PROJECT ID NO. SWQ0000005

**MONTEITH PARK AND VIEW PARK
GREEN ALLEY STORMWATER IMPROVEMENTS**

NOTICE INVITING BIDS

DR-14

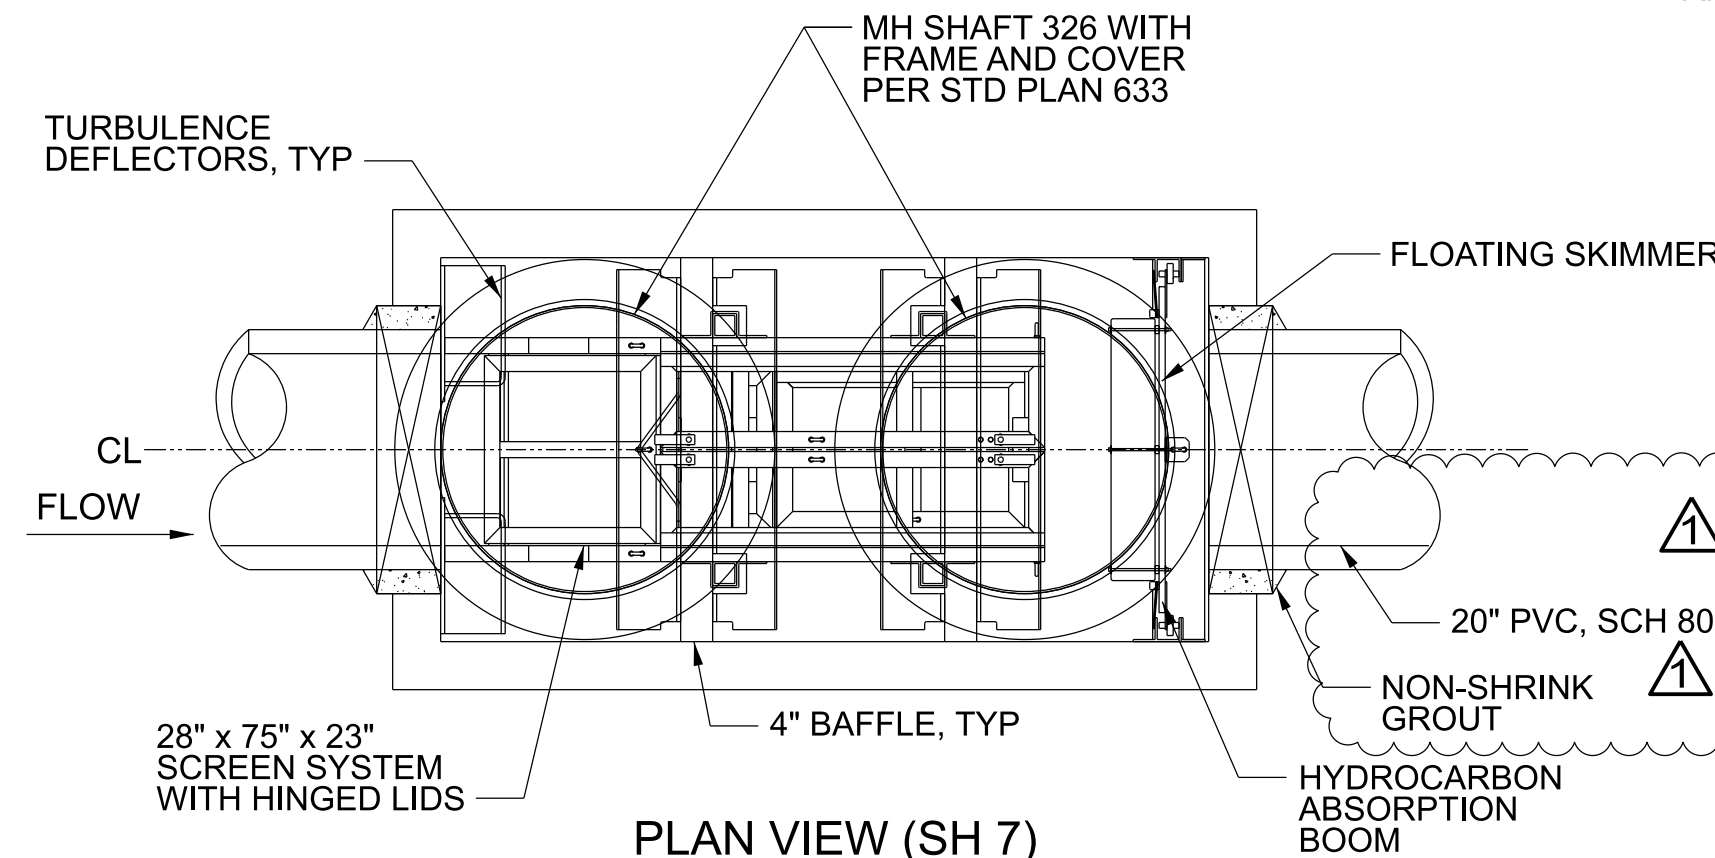
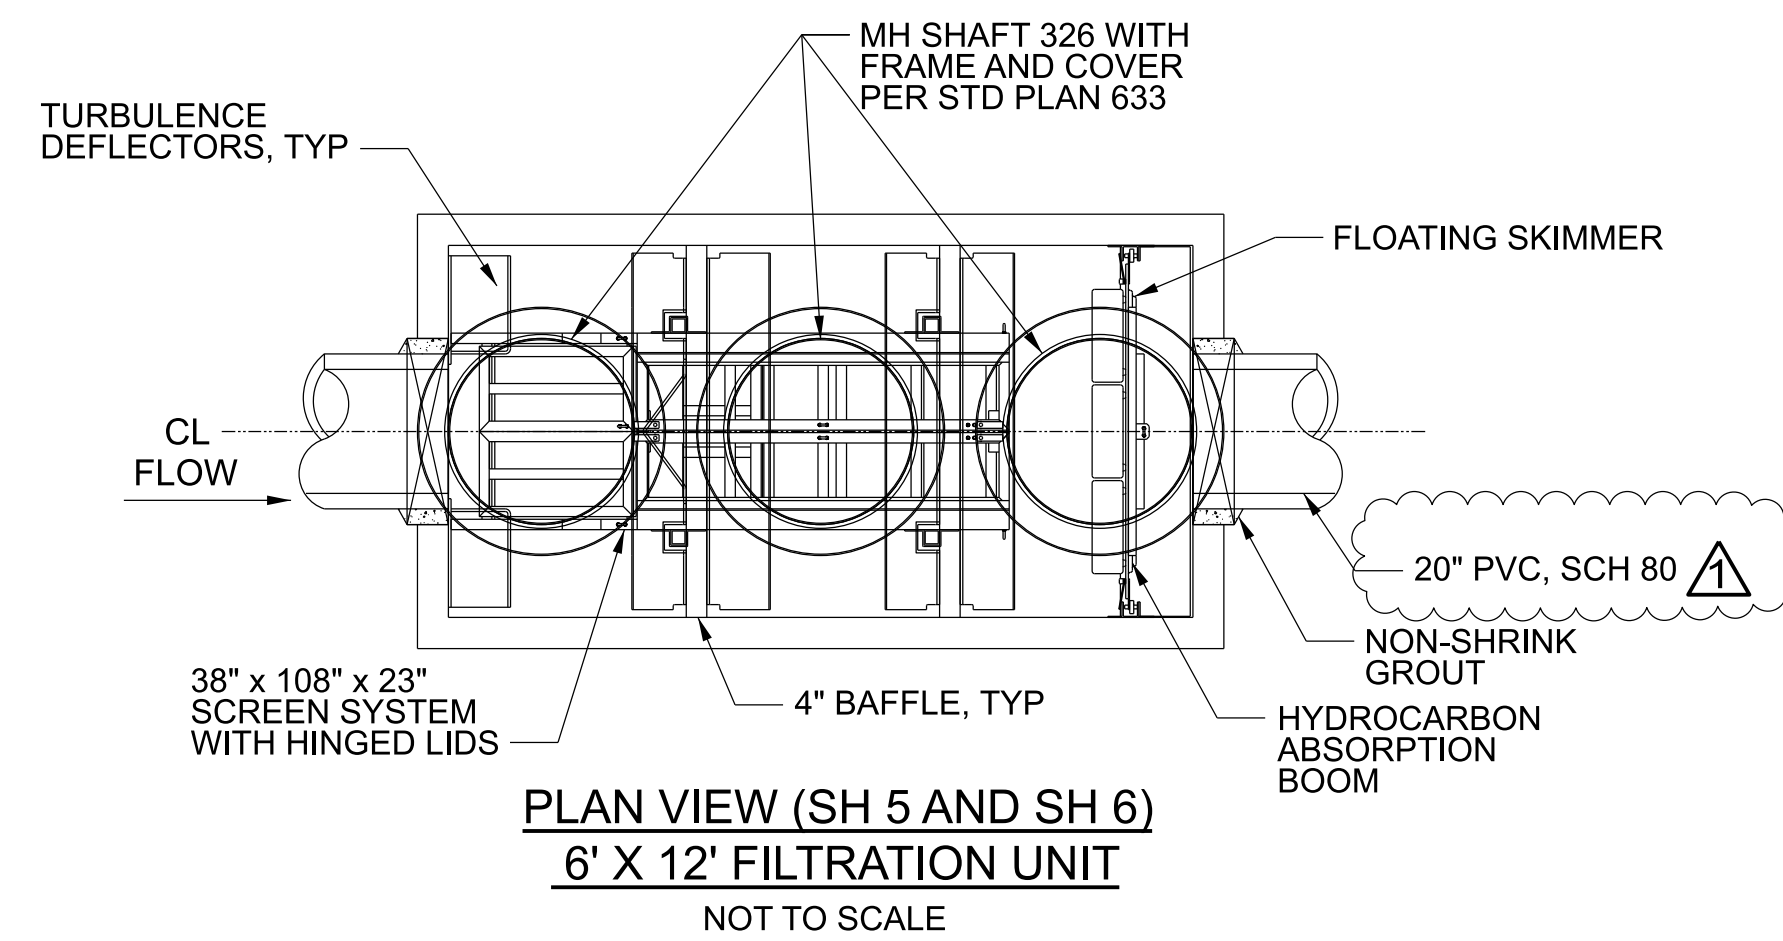
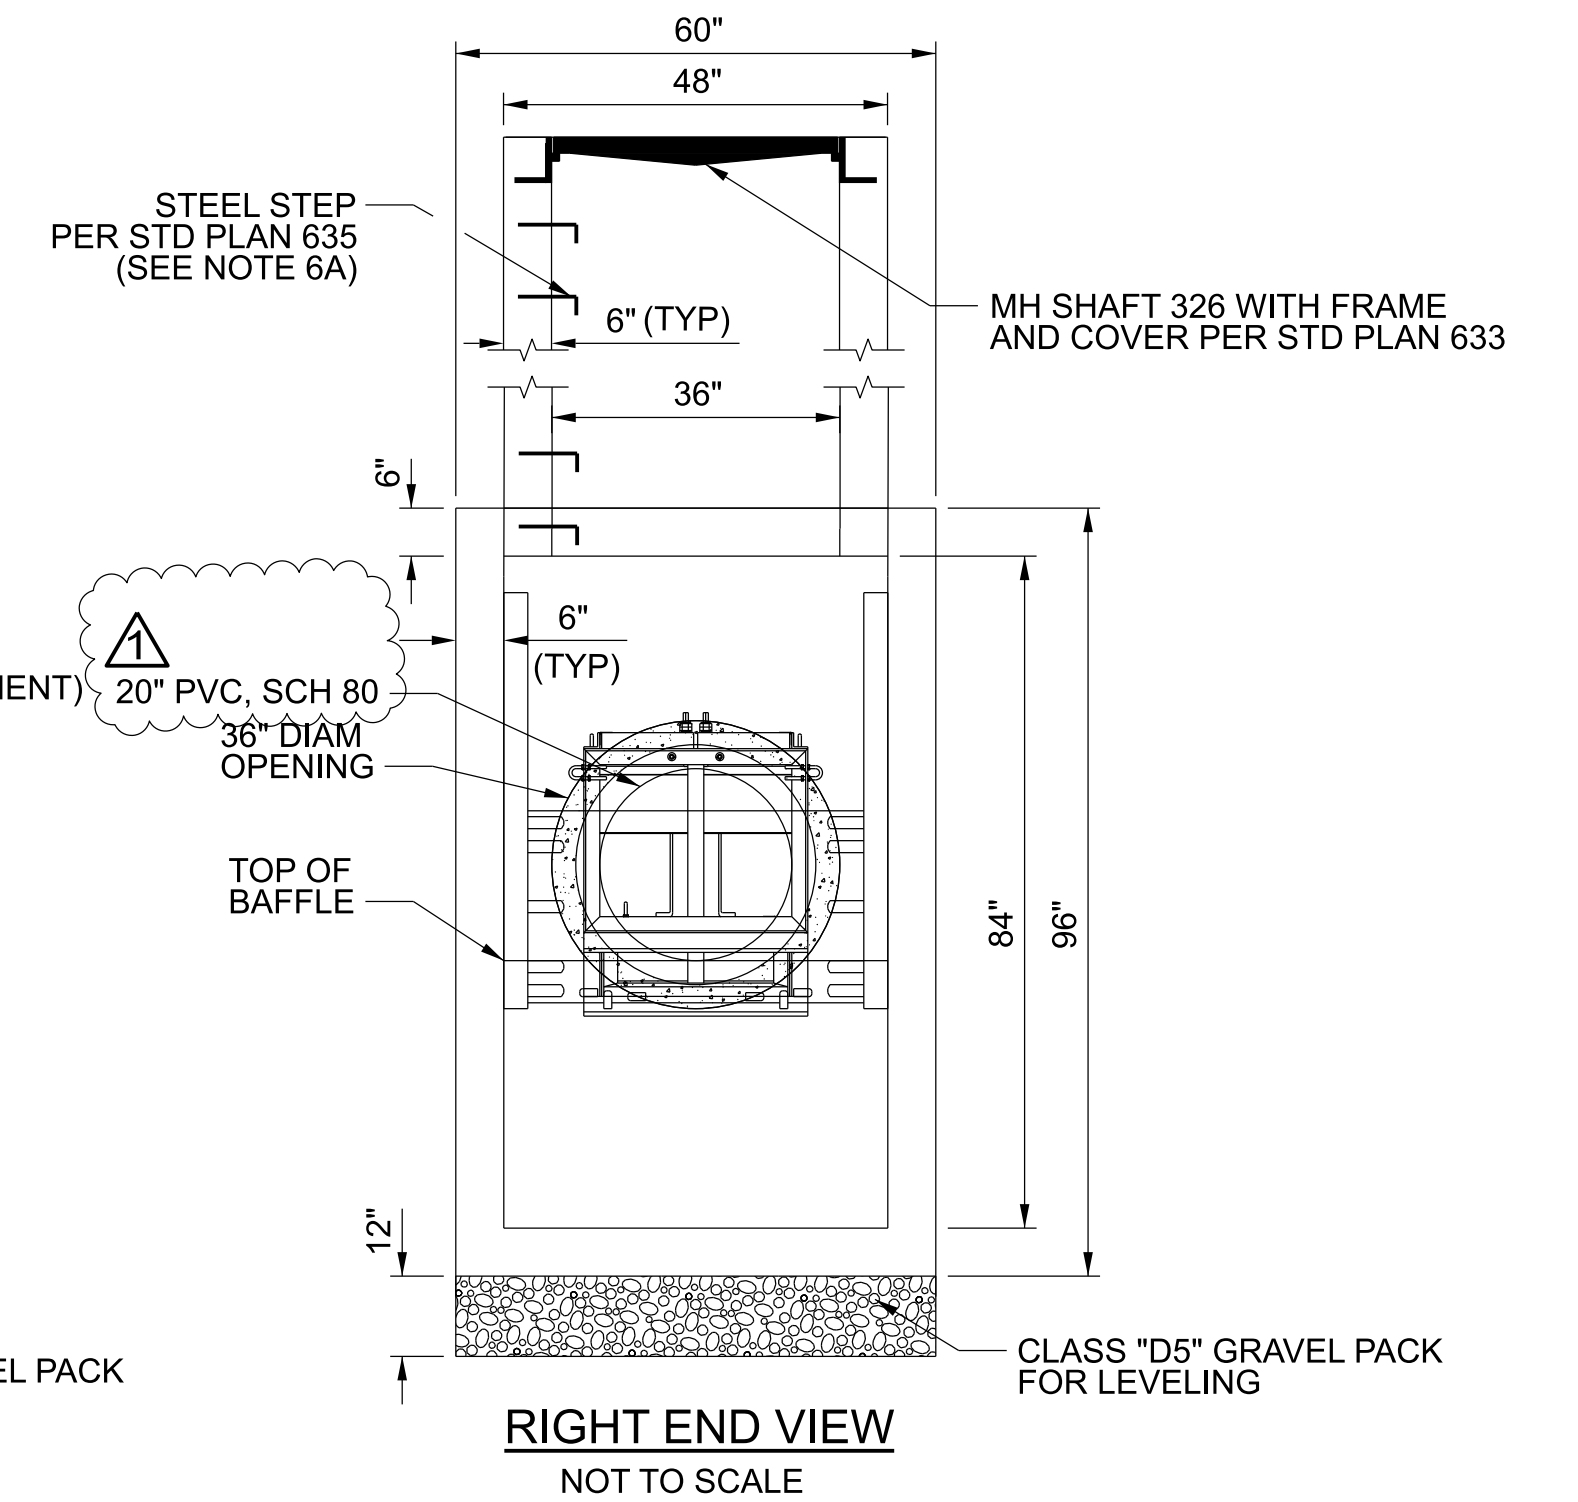
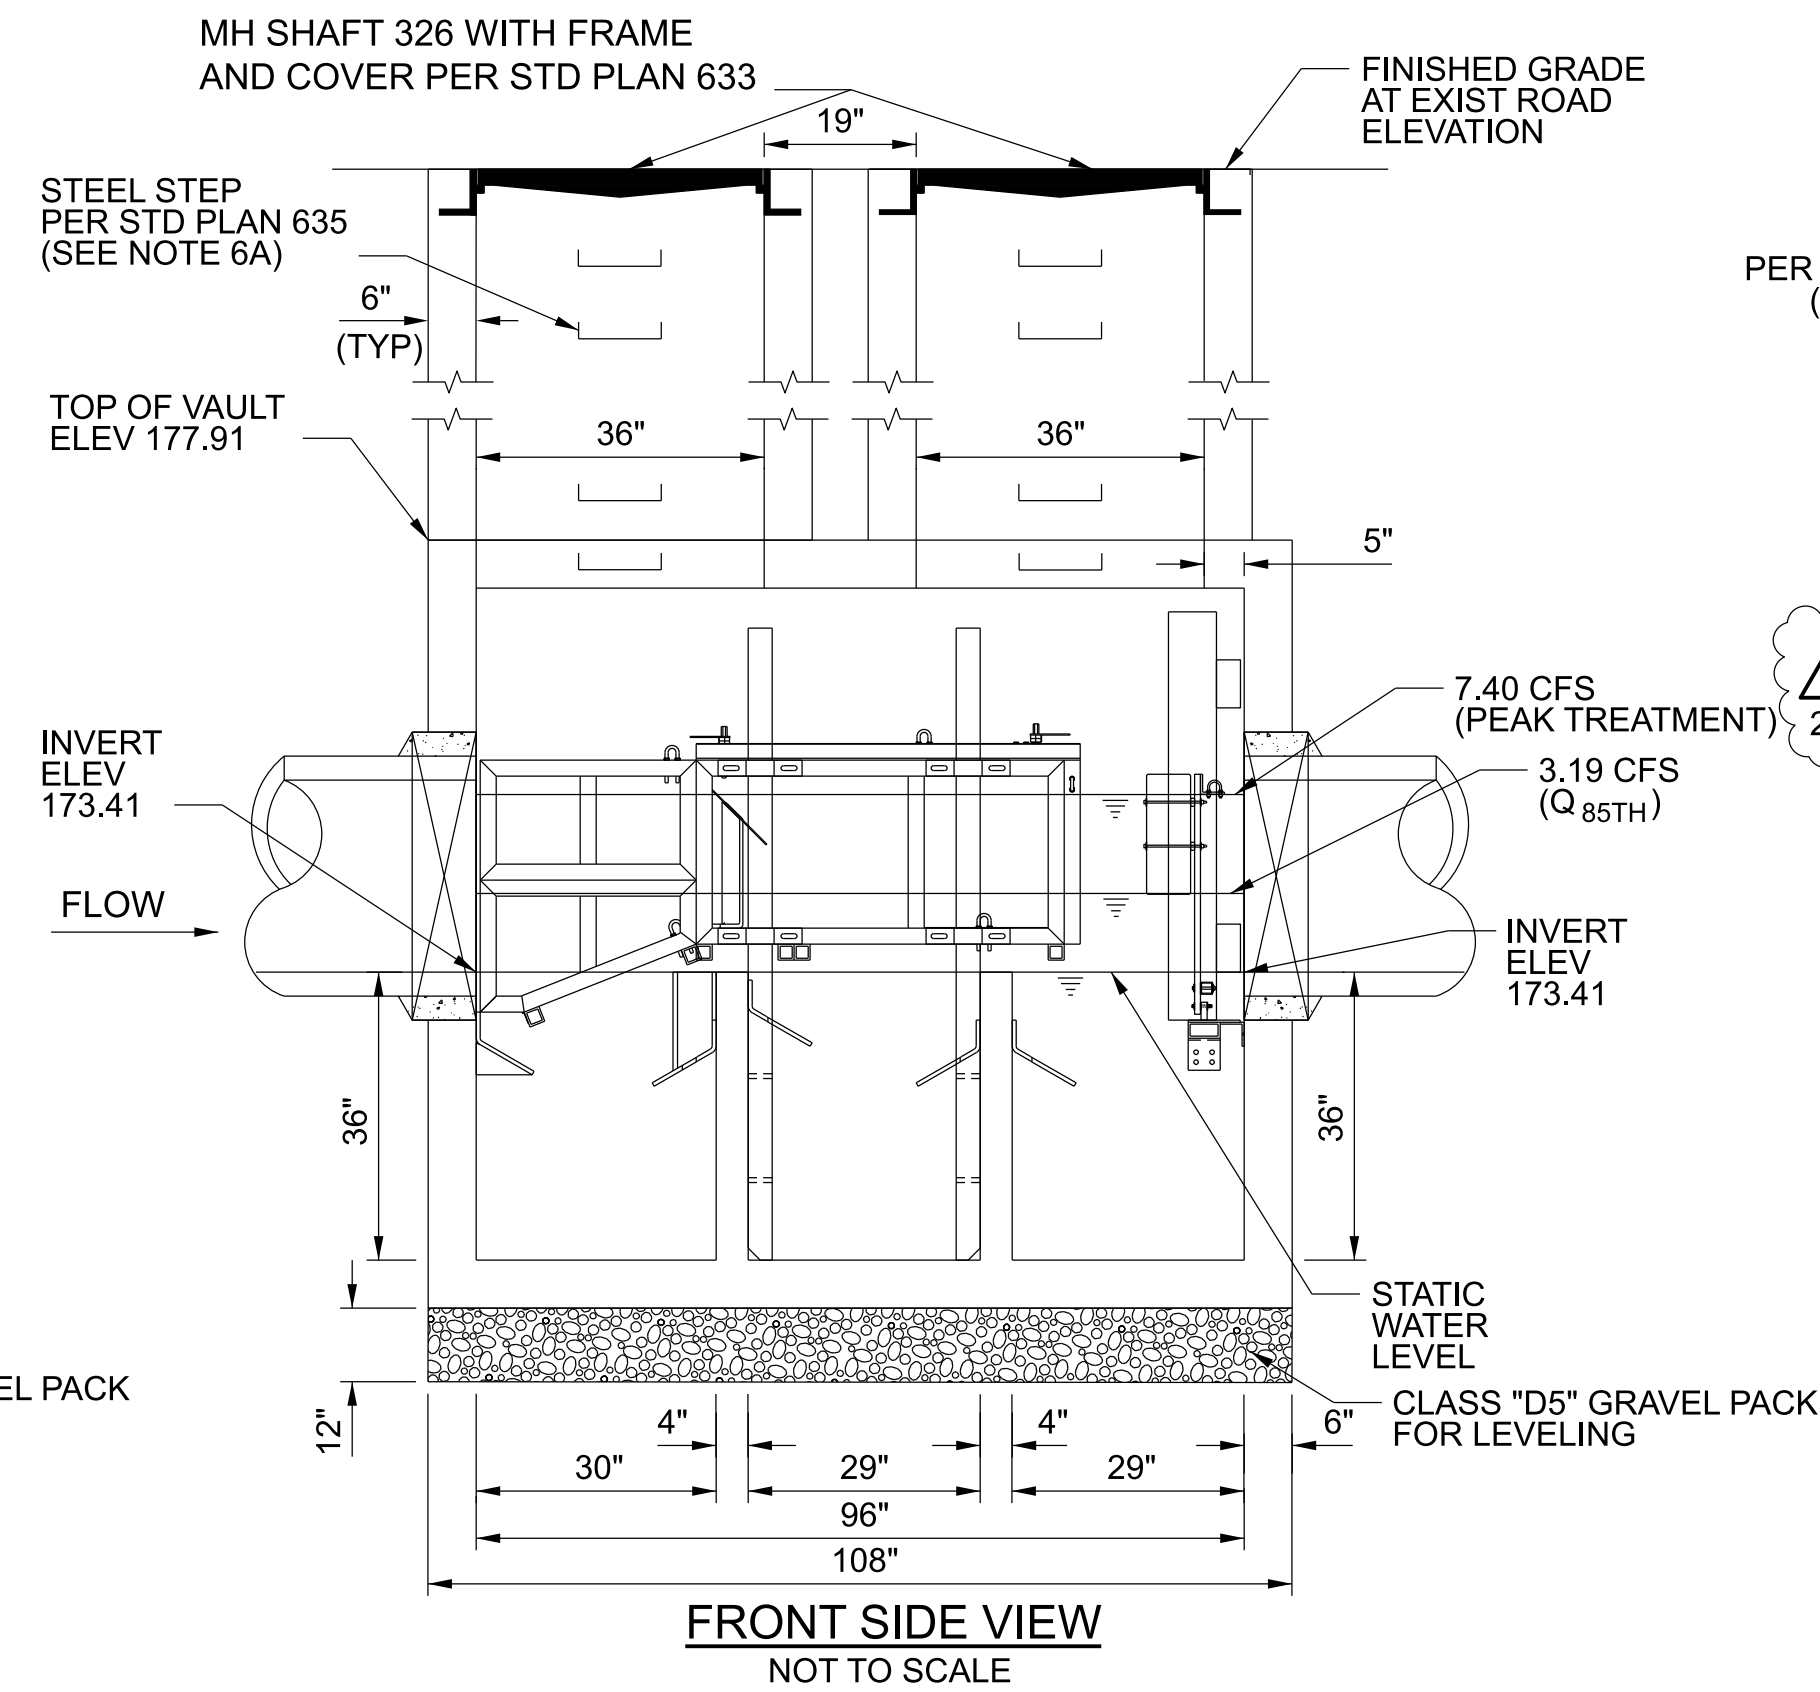
DATE	MK	DESCRIPTION
11/17/22	N. L.	CHANGED INFLOW AND OUTFLOW PIPE FROM 24" RCP TO 20" PVC

A64. All pipes going in and out of all 3 the filtration units shall be 20" PVC SCH 80. Refer to the revised Plan sheets included with this Addendum No. 2.
